## Addendum #1

### Project: Vancouver Community Library Deck Replacement and Structural Upgrade (ITB #2026-001)

**Aerial View / Access Markup**

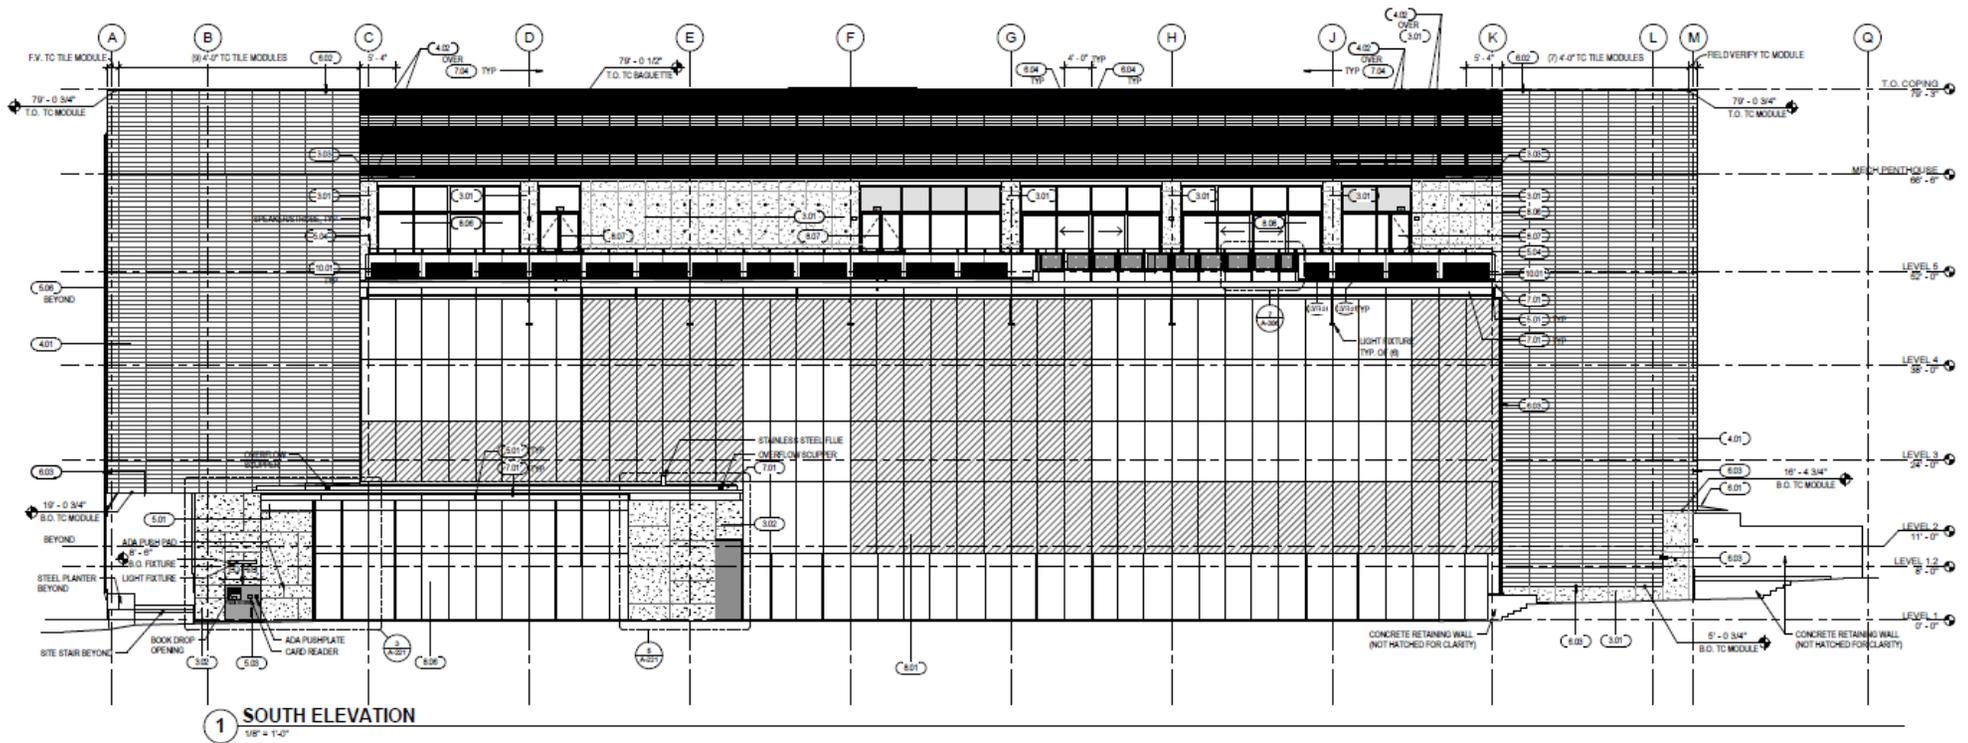
For the purpose of coordinating the removal of demolished materials, and the stocking of new deck structure and decking materials, see attached markup of possible access points. During the pre-bid meeting I remembered hearing something about the city allowing access, was that for area A or B? Also, can we get an elevation to the deck from ground level, along with estimated distances from each possible access point to the deck?

Please see the attached aerial view showing the space available for laydown area and loading/unloading. The deck elevation is approximately 52 feet (refer to elevation drawings).

We do not have estimated distances from various ground-level access points to the deck. Contractors are responsible for field verification of all dimensions. The library is a public facility. Contractors may visit the site to take measurements. Please check in at the front desk upon arrival.
